SUBJECT: Proposed Revisions to the Acceptance Criteria for Attic Vents, Subject AC132-0210-R1 (BB/WM)

PROPOSED REVISIONS TO THE ACCEPTANCE CRITERIA FOR ATTIC VENTS

AC132

Proposed February 2010

FIGURE 1—DUST-EXPOSURE TEST ON RIDGE VENTS

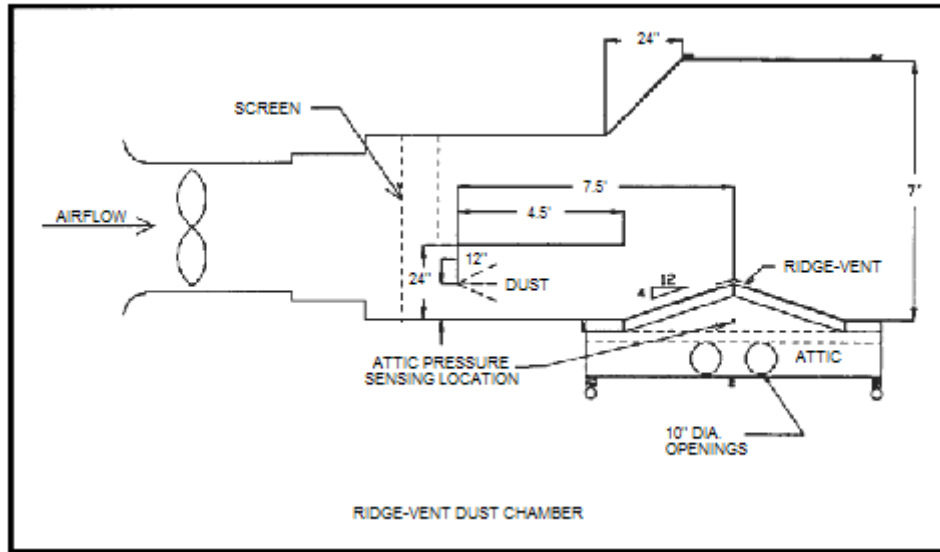
The test chamber shall be 2 feet (610 mm) wide and shall be 5 feet (~~4524~~ 1520 mm) high in the area upstream of the test deck. A 24-inch-wide-by-54-inch-long (610 mm by ~~1372~~ 1370 mm) horizontal divider shall be located 24 inches (610 mm) above the bottom of the chamber. The test deck shall be located such that the attic vent is level with the height at which dust is entrained into the airstream. The top of the chamber above the test deck shall transition to a height of 7 feet (~~2134~~ 2130 mm), as shown in Figure 1.
